| Project Title: | Energy System Reliability |
| Document Title: | Middle River Power LLC Comments - on Draft CEC Preliminary 2022 Summer Supply Stack Analysis |

Comments on Draft CEC Preliminary 2022 Summer Supply Stack Analysis

Figure 1 - July 2022 Preliminary Stack Analysis

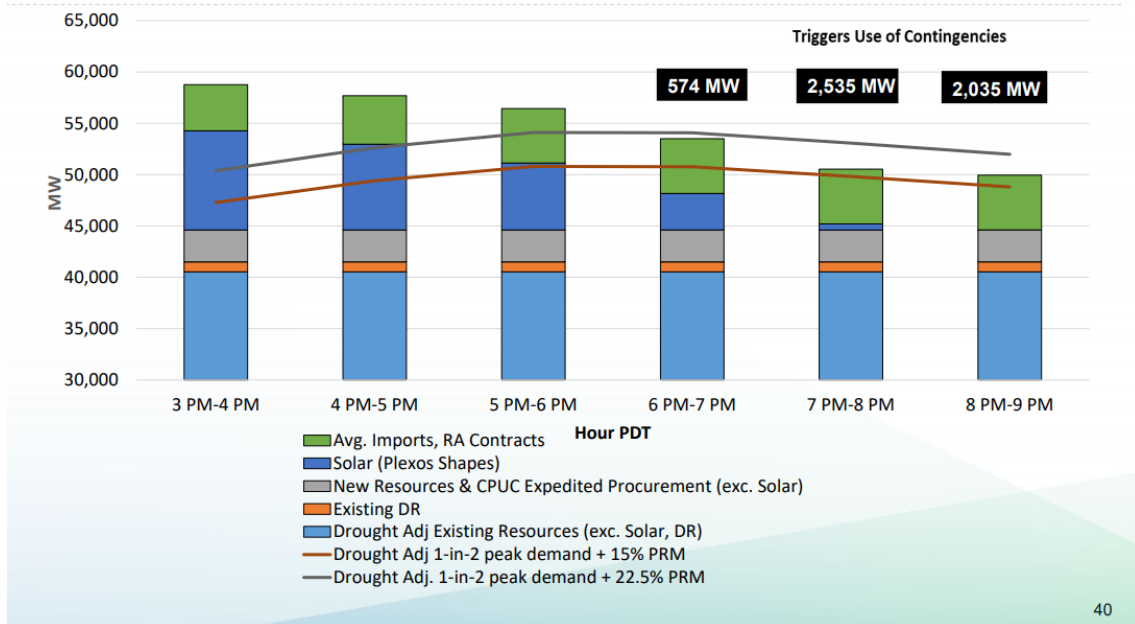
These charts all project resource deficiencies in Hour Ending 20 (HE20, 7- 8 PM) ranging from 2,480 MW to 5,274 MW using a 1-in-2 drought-adjusted peak demand forecast plus a 22.5% Planning Reserve Margin (“PRM”). Additionally, the September 2022 analysis projects resource deficiencies between 1,165 MW and 1,897 MW in HE19, HE20 and HE21 with a 15% PRM.

Second, the stack analyses all appear to assume that the same amount of demand response (“DR”) that is available at 3-4 PM also will be available at 8-9 PM. MRP questions whether DR program response generally lasts longer than four consecutive hours to allow for such counting in the stack analysis. This seems highly unlikely, and should either be amended or justified.

Third, the stack analyses appears to mix apples and oranges (i.e., capacity and energy) with regards to resource counting. The “drought-adjusted existing resources (excluding solar and demand response)” column, which includes wind and hydro resources, does not change across the six hours presented. It therefore appears to use capacity values for wind and hydro resources rather than the hourly energy profiles used for solar resources. MRP recommends that, for variable resources (i.e., solar, wind and DR programs), the analysis should use conservative estimated hourly profiles rather than static MW capacity values associated with RA net qualifying capacity (“NQC”). For DR, if estimated hourly profiles are not readily accessible, then the next best option is to limit the duration in which DR programs would generally be dispatched.

Fourth, for each of these three months, the figures show the same value for “average imports, RA contracts” across each of the six hours. Inspecting these figures appears to show values of greater than 5,000 MW for imports for these three months in 2022. While the 2022 RA annual showings have not yet been made, MRP respectfully encourages the Commission to use prudently conservative assumptions about the availability of imports. MRP agrees that import values should be based on RA contracts, which should indicate that resources are committed to serving California load, and should not be based spot market import energy sales, which do not indicate whether the backing resources are, in fact, committed to serving California load.

Figure 2 - August 2022 Preliminary Stack Analysis

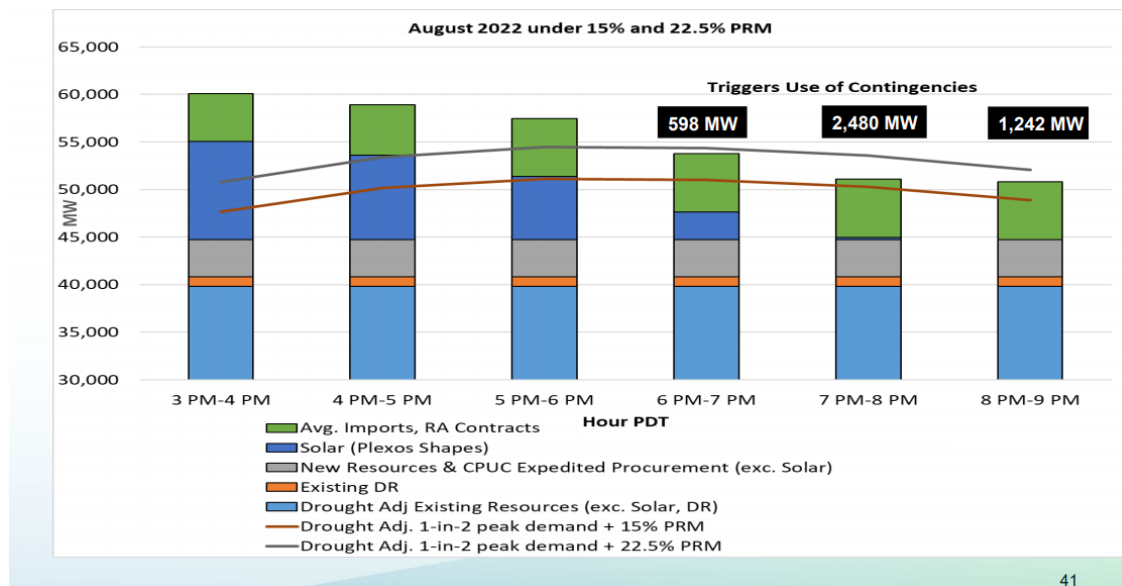
Sixth, the analysis indicates that nearly 5,000 MW of new resources will be available for August 2022. MRP questions if the Commission assumed correctly that such new resources, which MRP expects will be four-hour battery resources, are truly available for the entire six-hour duration of HE 16 through HE 21. To the extent that such new resources are primarily four-hour storage resources, the analyses should only reflect the reliability contribution towards the hours of most need. Better shaping the new resource stacks to reflect four-hour availability may

With regards to new resources, the analyses seem to indicate that nearly 5,000 MW of new resources will be available for August 2022, but that approximately only 4,000 MW of new resources are expected to be available for September 2022. Given the presumption that any new resources that is available for August will also be available for September, the difference between these August and September values, if they are, in fact, capacity values, is unclear. If the values are not capacity values, but energy values, then it is not clear why the values would be same for all six hours and not shaped, especially if the underlying resources have solar components.

Figure 3 - September 2022 Preliminary Stack Analysis

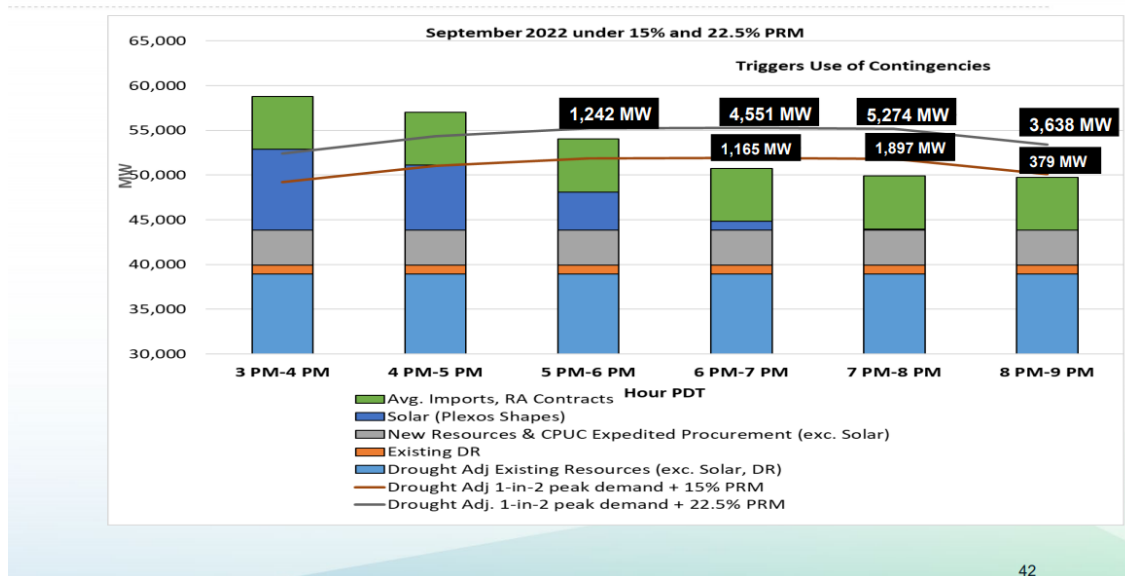
reveal deficiencies in other hours as well. For example, it is possible a deficiency may occur during HE 21 if the new four-hour resources are all used up by HE 20. Likewise, if the four-hour resources are “saved” for HE 18 through HE 21, then deficiency may occur at HE 17 during September in this stack analysis, though such deficiencies are less likely because of the additional solar production at HE 17. In any case, given the expectation that many of the new resources procured will be four-hour battery resources, the stack analysis should not assume those resources are available for a six-hour strip.

Figure 4 - CAISO Five-Minute Data from July 9, 2021

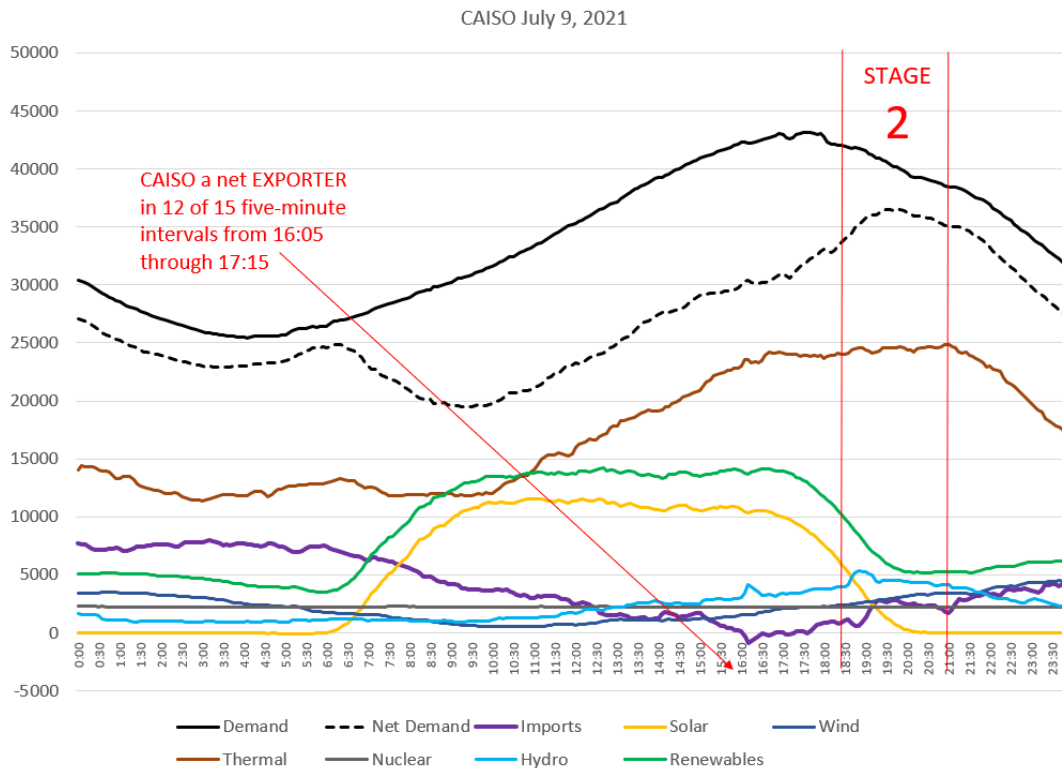
Further, assuming that California will have access to historically “average” levels of imports even based on RA import contracts may be an unwise assumption. MRP notes that the CAISO was a net *exporter* across its peak gross demand on July 9, the day on which the CAISO observed its peak demand for 2021 to date. As Figure 4 shows, the CAISO’s net imports were in the range of only 2,000 – 2,500 MW across its net peak demand time that same day. MRP acknowledges that multiple factors limited imports this day, including high temperatures in the Pacific Northwest (which caused high demand in other western load centers) and wildfire-driven reductions in transfer capability on both the California Oregon Intertie and the Pacific Direct

Current Intertie. Nevertheless, these factors (increased competition for fewer resources across the west and wildfire-induced resource and transmission restrictions) suggest that it would be unwise to place undue reliance on out-of-state resources whose energy must be delivered on long-haul transmission.
